ADVISORY DRAWING..
60-62 WILLIS LANE, WHISTON

Our Ref: 00/00171/FUL

TOWN AND COUNTRY PLANNING ACT 1990
ERECTION OF DWELLING, LAND AT 60-62 WILLIS LANE, WHISTON, KNOWSLEY, MERSEYSIDE.

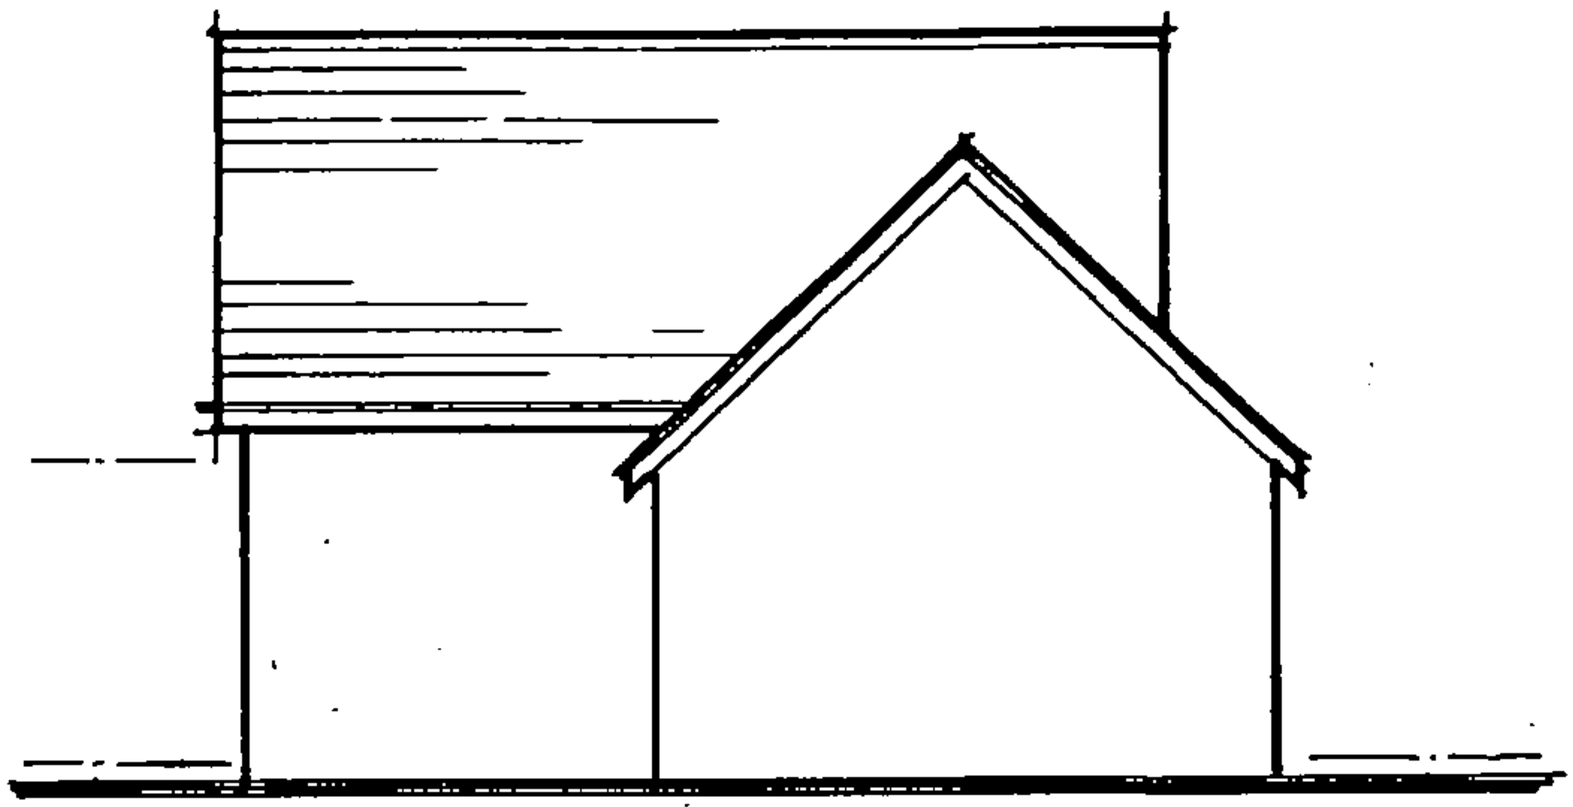
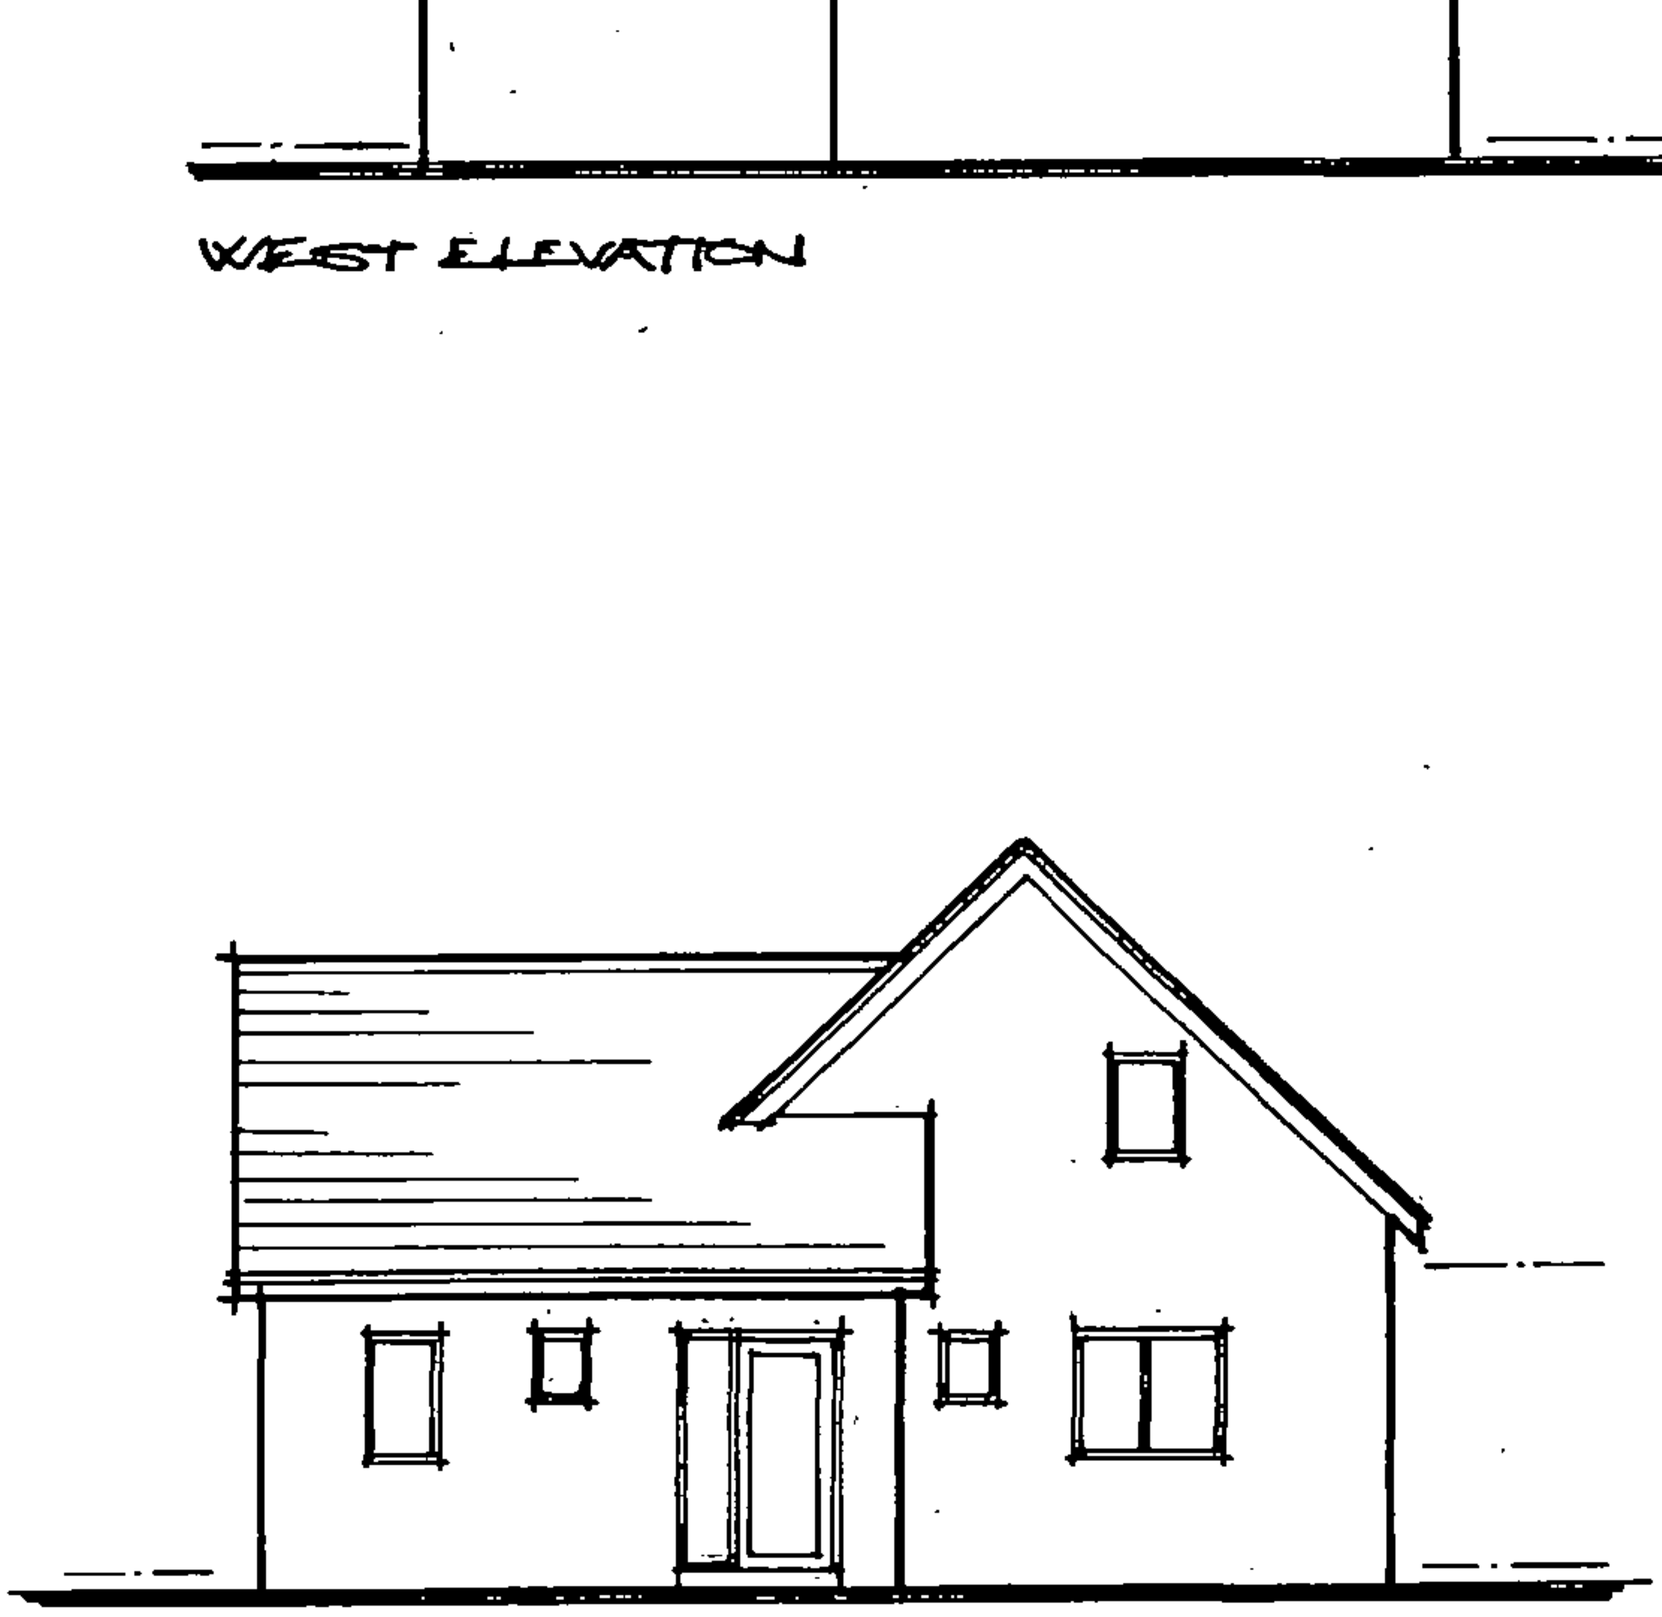
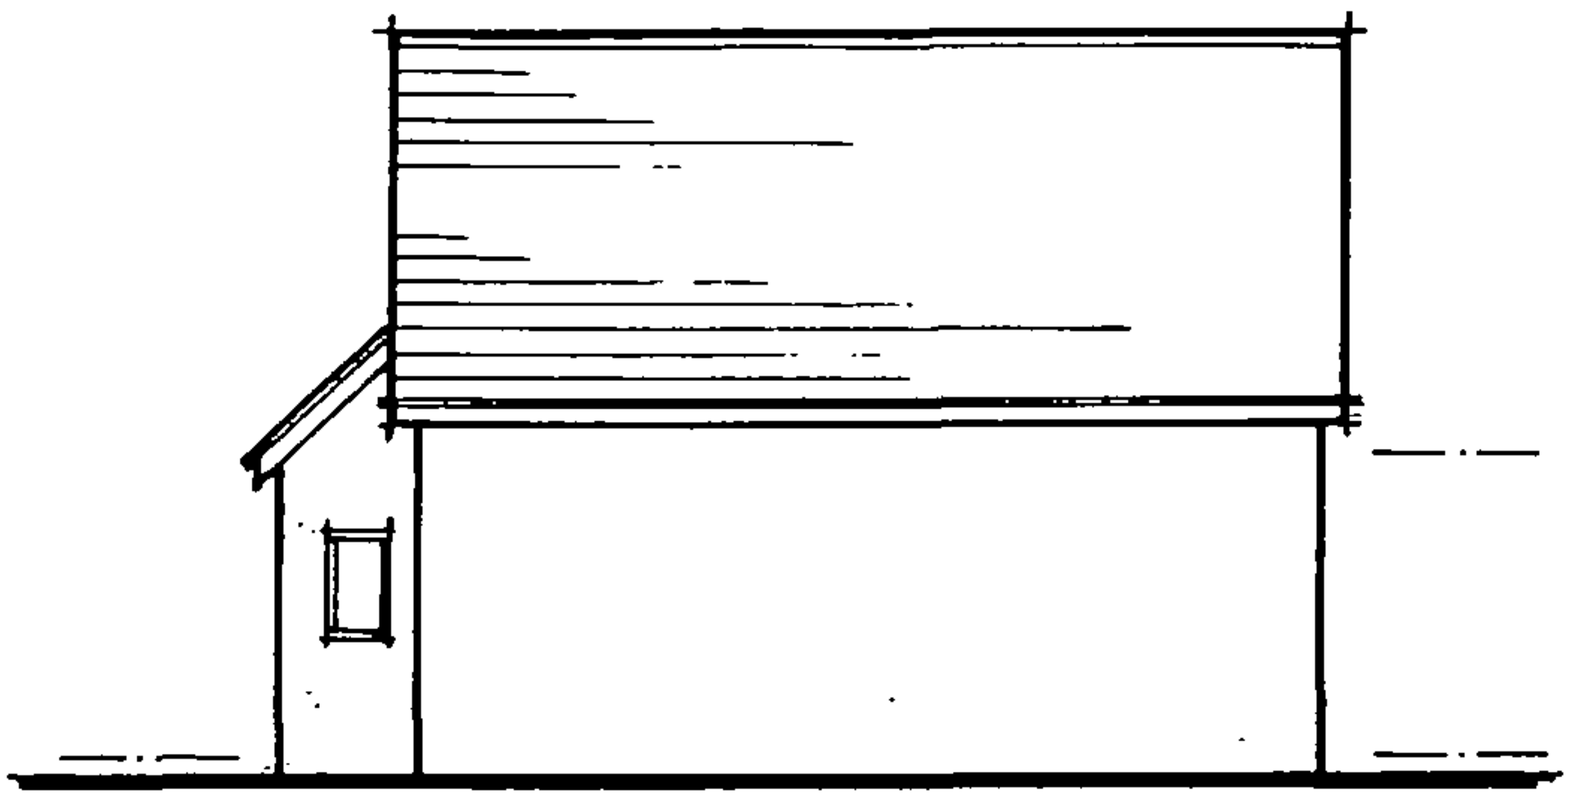
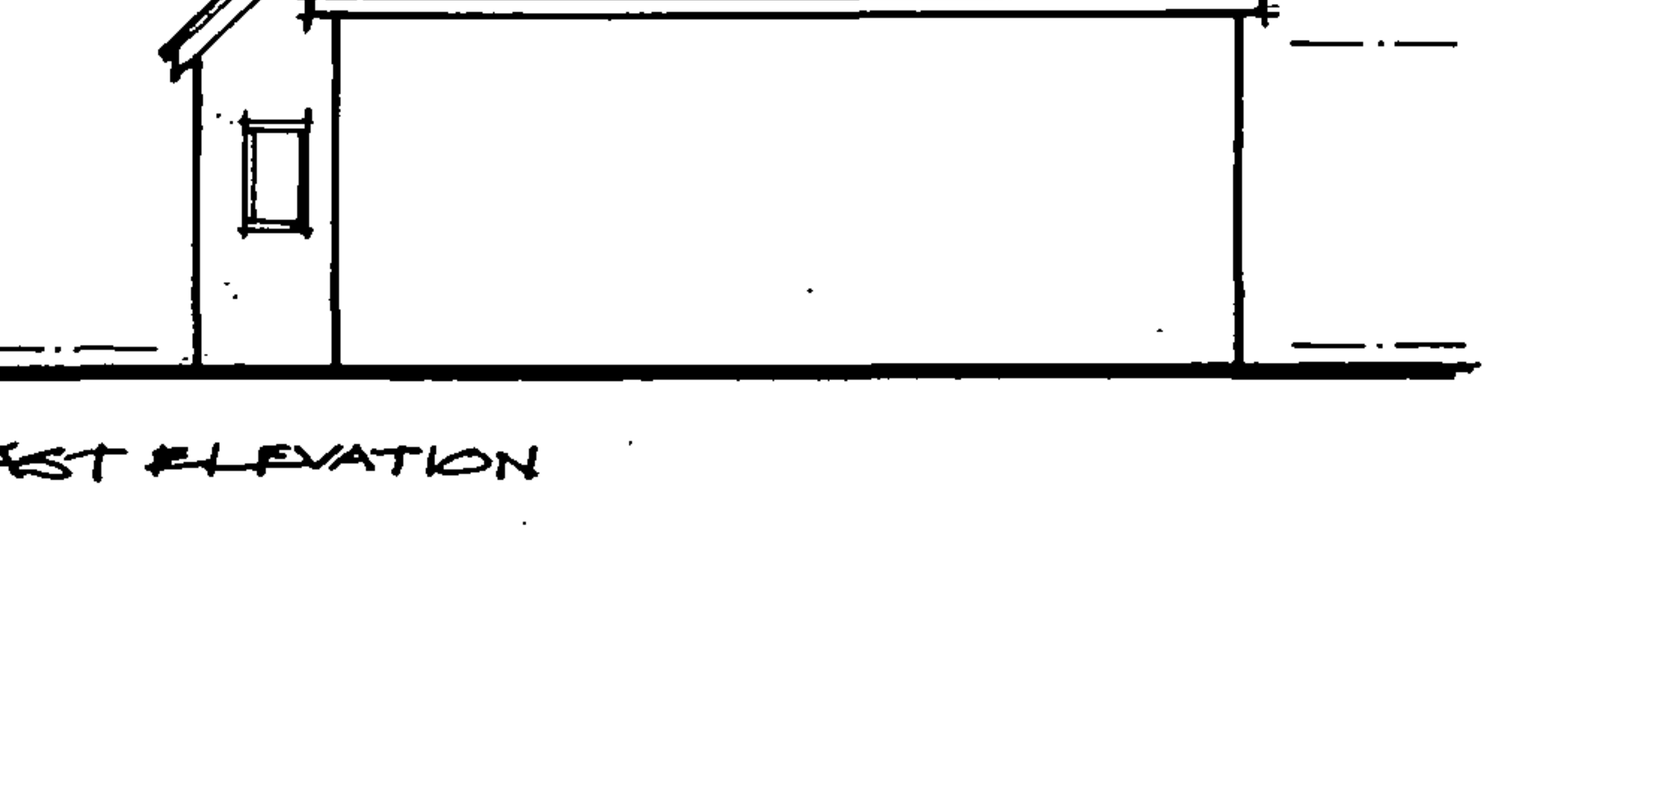
- Amended plans now show a two-storey dwelling whereas the original proposal was for a dormer bungalow and likewise so were the advisory drawings.

- The ridge height of the gable is now shown at 4.5 metres whereas it was shown as 3 metres on advisory drawing. In addition the roof pitch of amended drawings is shown at 25^0 this was approximately 47^0 on advisory drawings and the roof to the main gable shown at 8m whereas the advisory drawings showed this at 7.6 m. It is felt that this would therefore have a far greater impact and would seriously detract from the amenities of adjacent occupiers given that the siting of the building could not meet with the spacing requirements set out in the UDP for main rear elevations to flank walls. In addition, the massing of the building would result in an overly dominant building on this small plot, thus detracting form the street scene.

ADVISORY DRAWING ..
60-62 WILLIS LANE, WHISTON

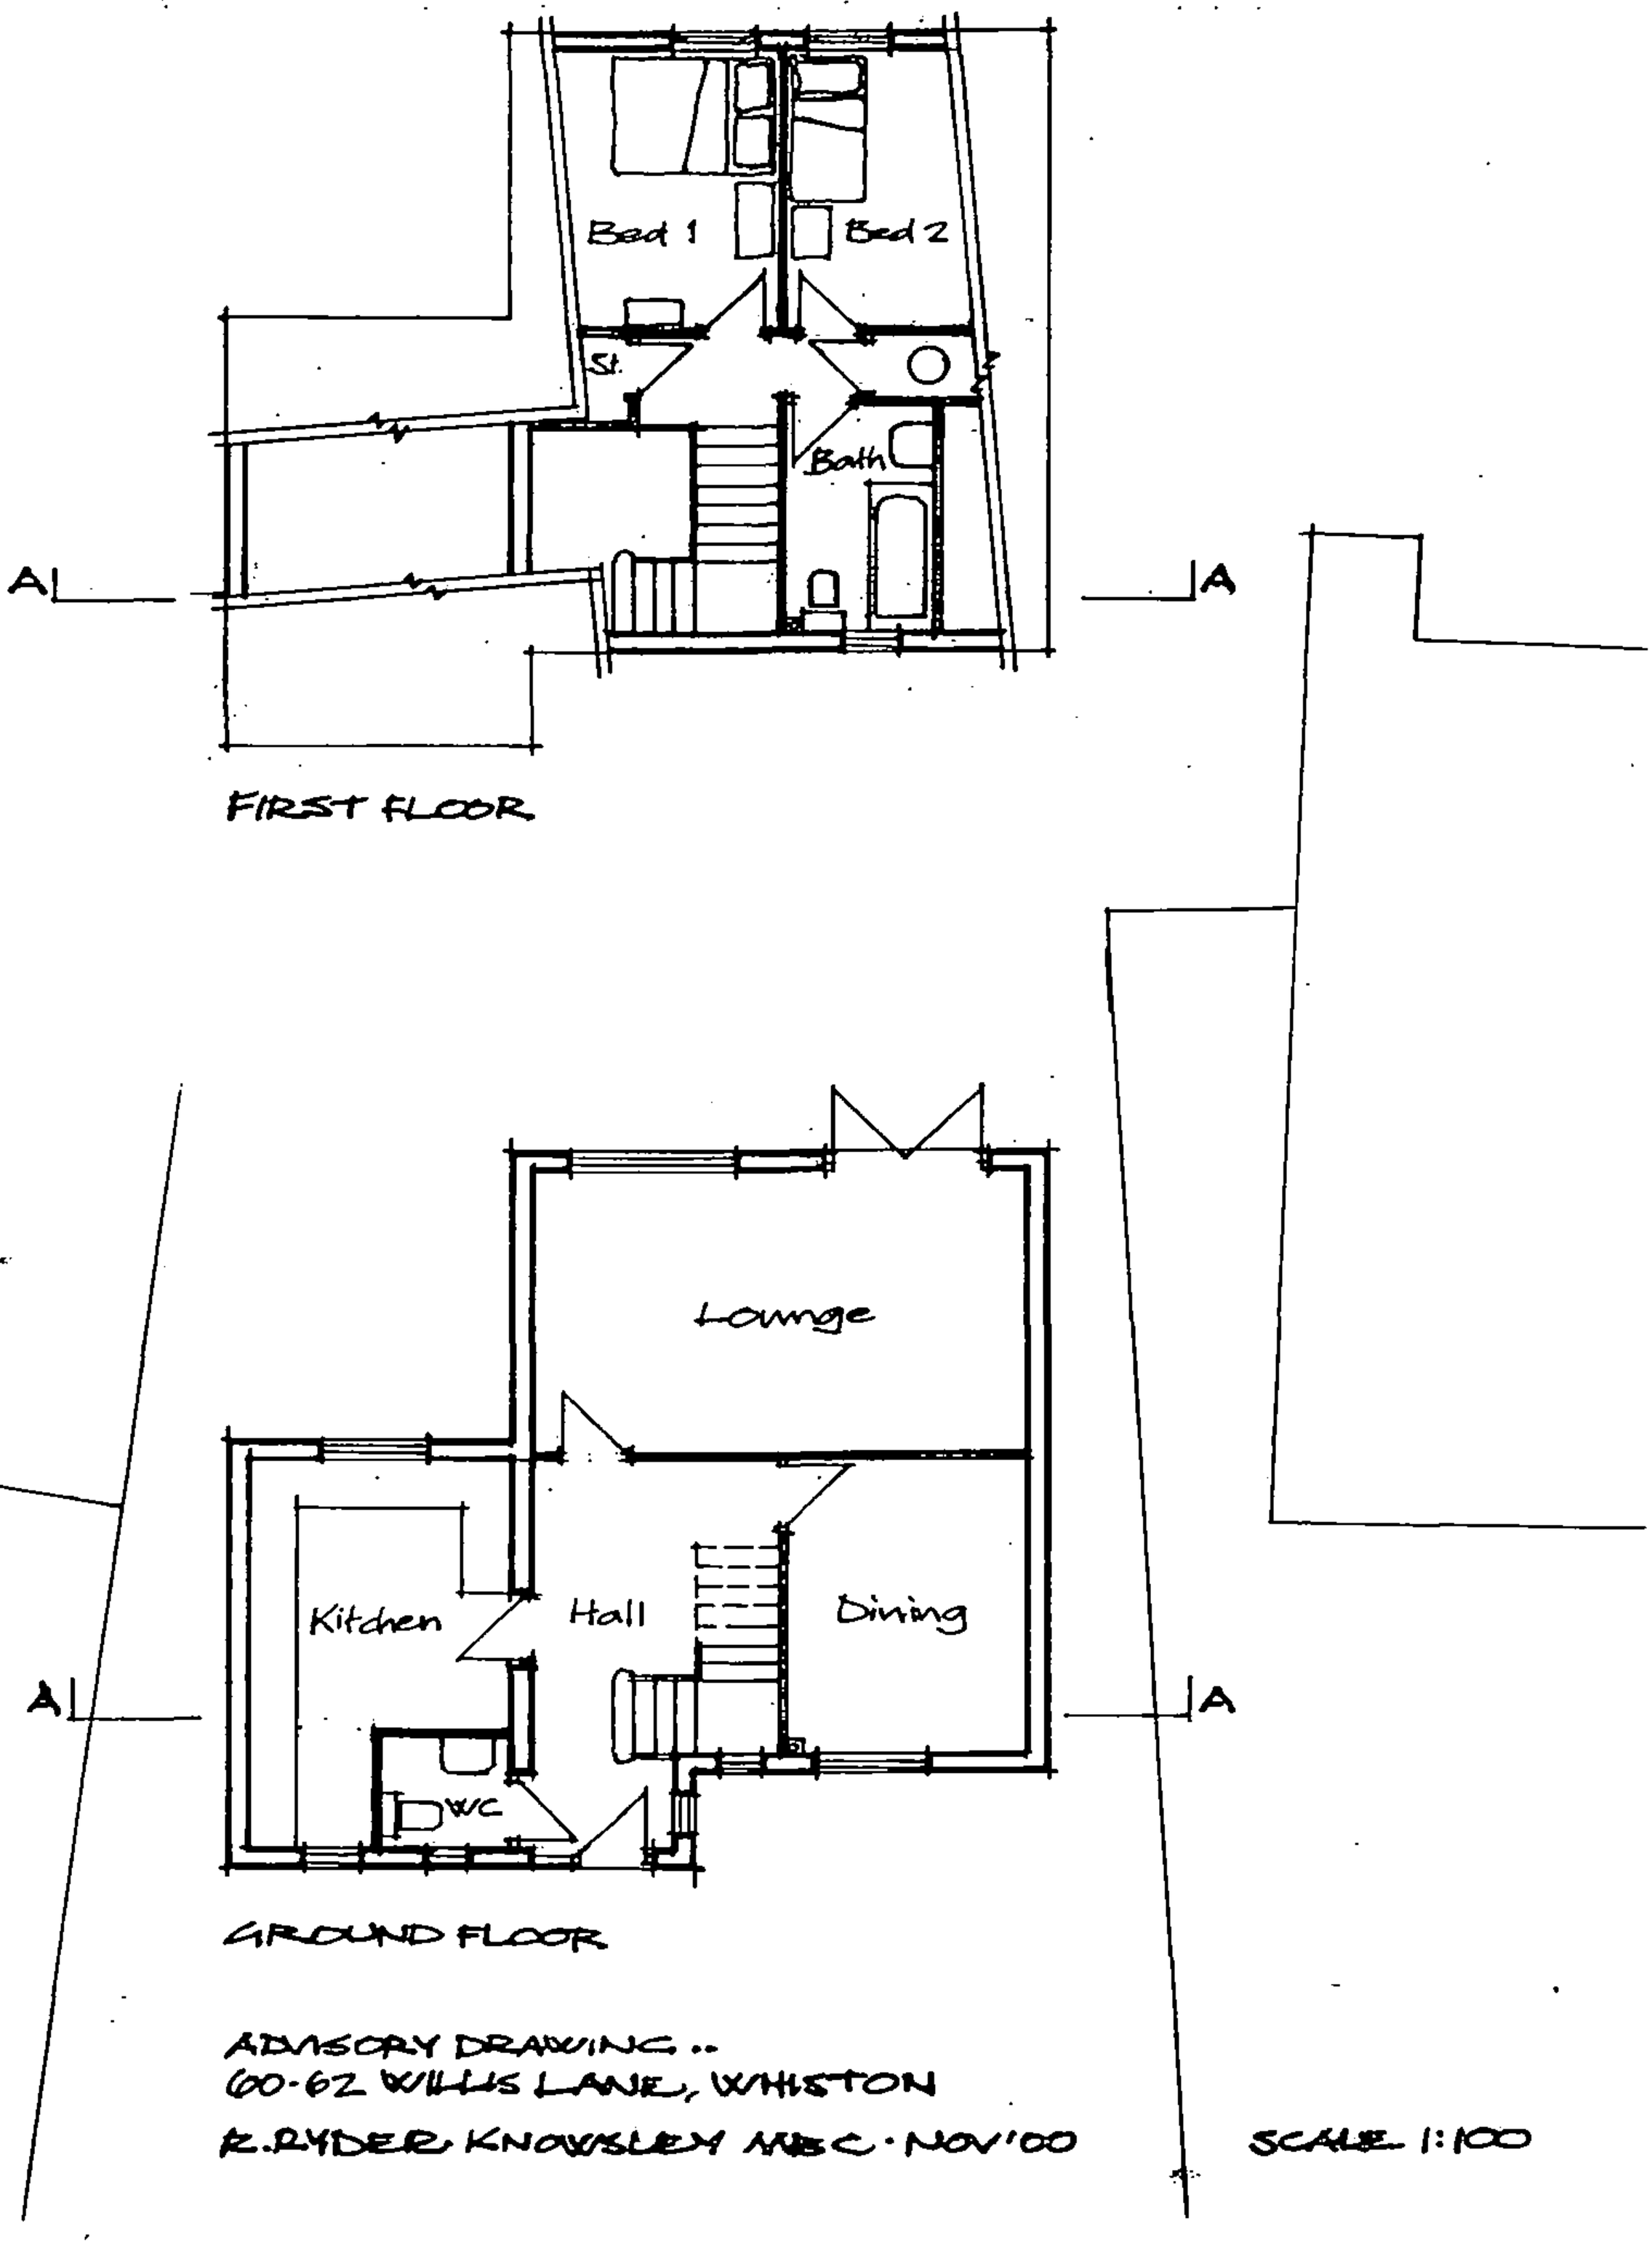
- Garage indicated is too small to be acceptable size for garage (UDP standards 6m long by 2.7 m wide). Therefore, 2 no. parking spaces would need to be provided within the curtilage. This would require the rearrangement of the front layout to provide 2 spaces @ 2.4m wide by 4.8 m long. In addition, Highways would like to see a 1.8 m wide footway along Willis Lane. The 2 no. spaces together with the footway could be

achieved to the front of the dwelling as indicated on the amended plans and the necessary visibility splay of 2.4m x 40 m co-extensive with the site frontage.
